Title **Relaying RNG-REQ/RSP for MS Network Entry**

Date Submitted **2007-03-05**

Re: Call for technical proposals regarding IEEE project P802.16j

[This contribution proposes text to clarify RS operation of Ranging Process for distributed controlled RS.](#)
~~[This contribution proposes the scheme with which RS supports MS scanning operation.](#)~~

Figure <XXX>03—Ranging and automatic adjustments procedure in MR mode

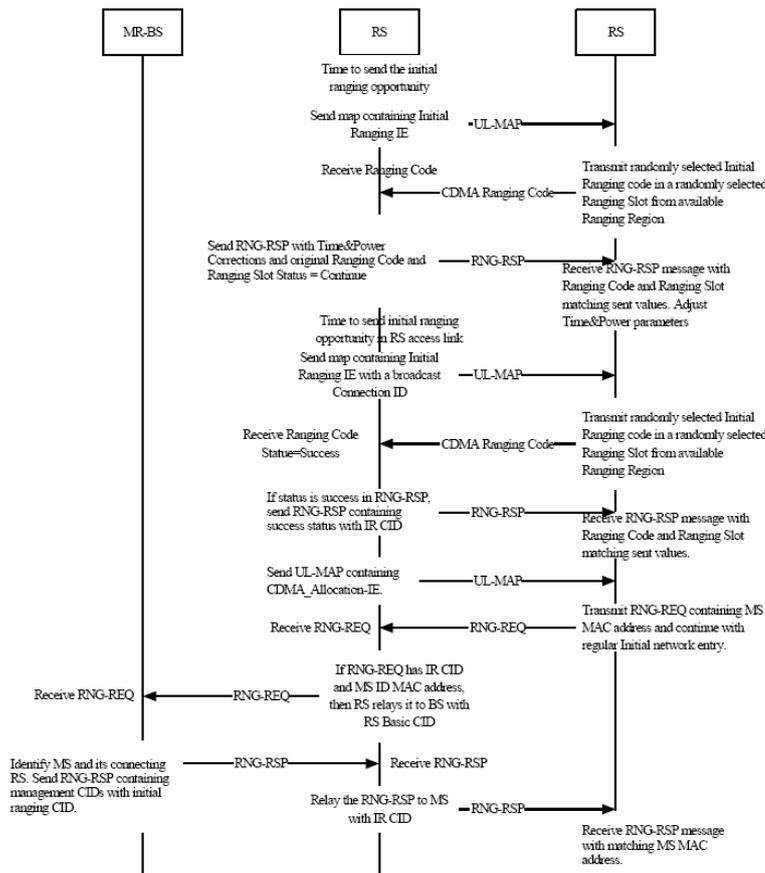
In IEEE 802.16j Baseline document 06/026r2, the initial ranging process in Non-transparent RS with Distributed scheduling as defined at section 6.3.9.16.2.2 as described in the figure <XXX>03.

However, when a RS relays RNG-REQ and RNG-RSP between MS and MR-BS, some field in the message is appropriate to be responded by the RS. For example, the Downlink Operational Burst Profile for a MS in RNG-RSP should be responded by the RS since the RS is the actual node which is physically communicating with the MS.

"Receiving the RNG-REQ containing the MS MAC Address, the RS may decide which TLV is managed by itself in the RNG-RSP. If there is any field to be managed by the RS such as Downlink Operational Burst Profile, the RS omit the TLV from the RNG-REQ and recompose the RNG-REQ message. The RS transmit the RNG-REQ message~~relays it~~ with the RS basic CID instead of IR CID in the header to MR-BS.

Once the MR-BS receives the RNG-REQ containing MS MAC Address with the RS basic CID, the MR-BS shall assign Basic and Primary management CIDs to the MS, and transmit a RNG-RSP containing those management CIDs and MS MAC Address with the RS basic CID.

The RS receiving the RNG-RSP containing the management CIDs and MS MAC Address may add the TLV field which is managed by RS and shall transmit~~relay~~ it to the MS with the initial ranging CID..."
